This gallery shows some pictures of bad solderings - they should prevent you from making the same errors (feel free to add even more pictures here!)

Permanent link:
http://www.midibox.org/dokuwiki/doku.php?id=home:skills:bad_solderings_gallery&rev=1228123119

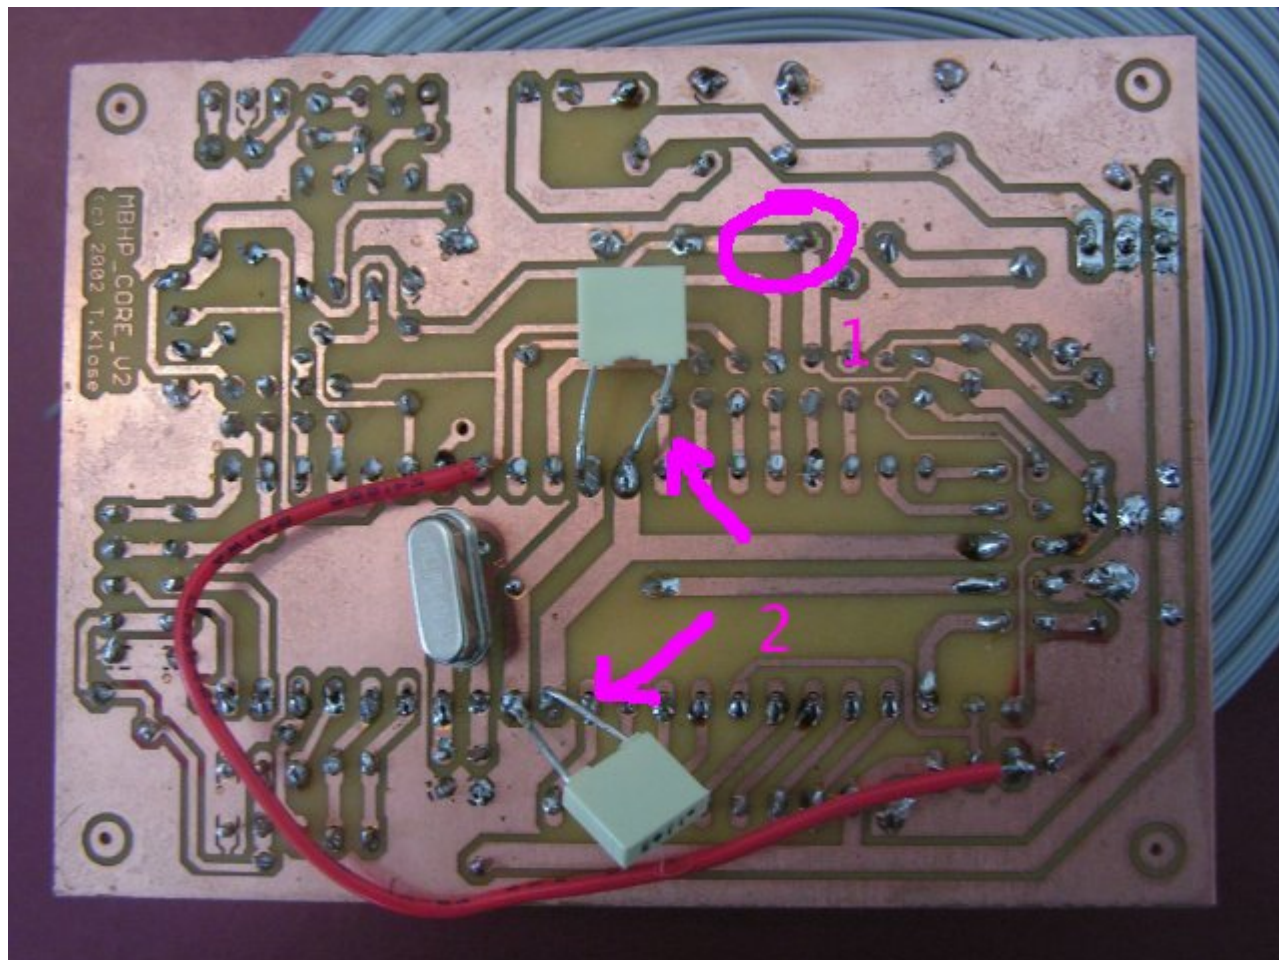
1: The core module has some badly soldered connections(loose), which could lead to failures. There are also missing solderings (e.g. 33pF cap below crystal). It makes sense to solder each pad again, the [Soldering](#) guide in the Wiki gives some useful tips

2: The legs of the caps should be cut, otherwise they can cause a short circuit which can damage the PIC!

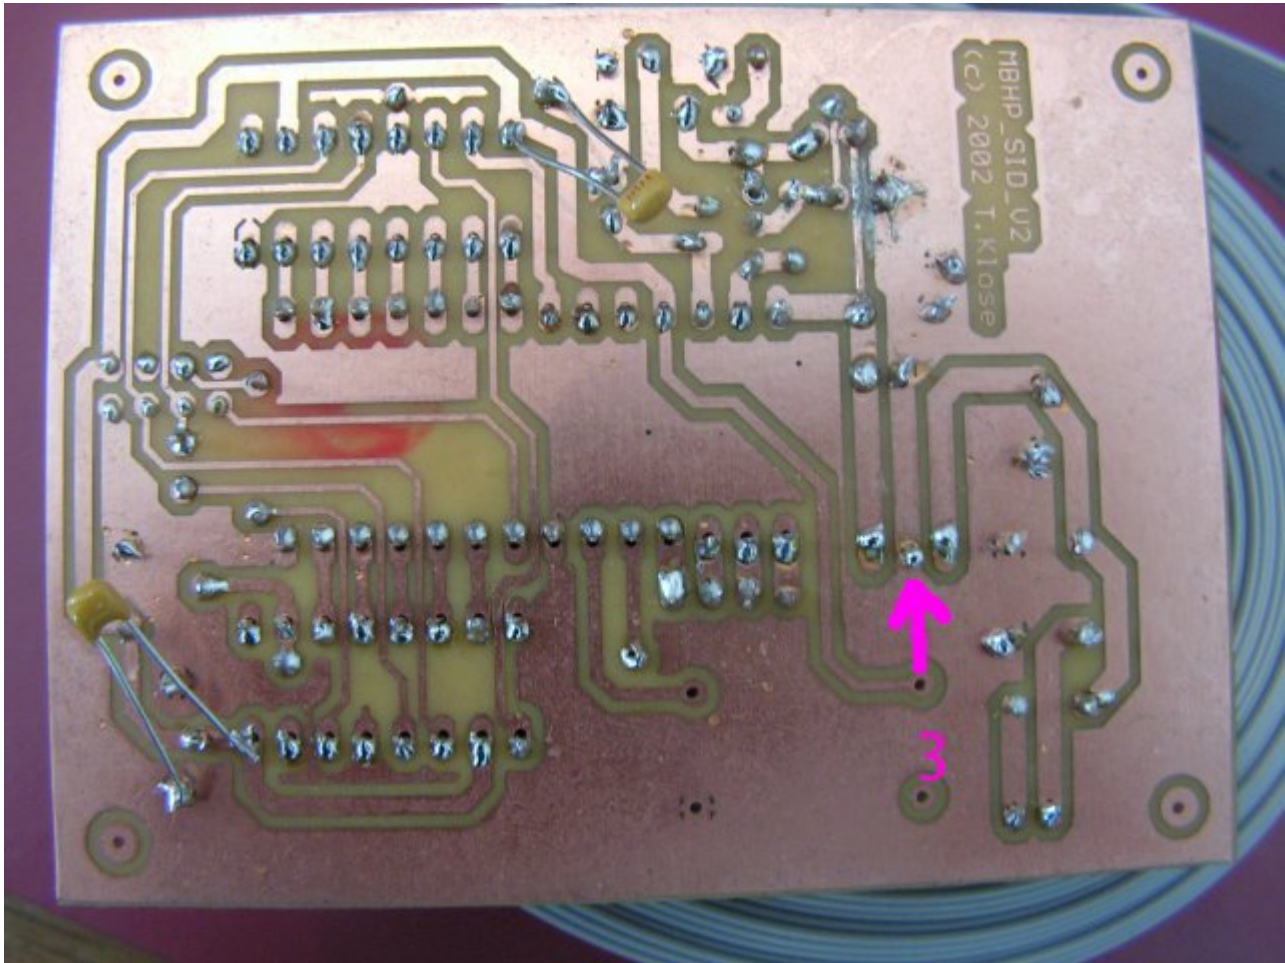
3: This seems to be a bad ground connection directly at the 78xx - it can lead to the wrong voltage. Here the same: just solder the pads again, it will help
And same as above: the long cap legs need to be cut, the danger of shorting out is too high!
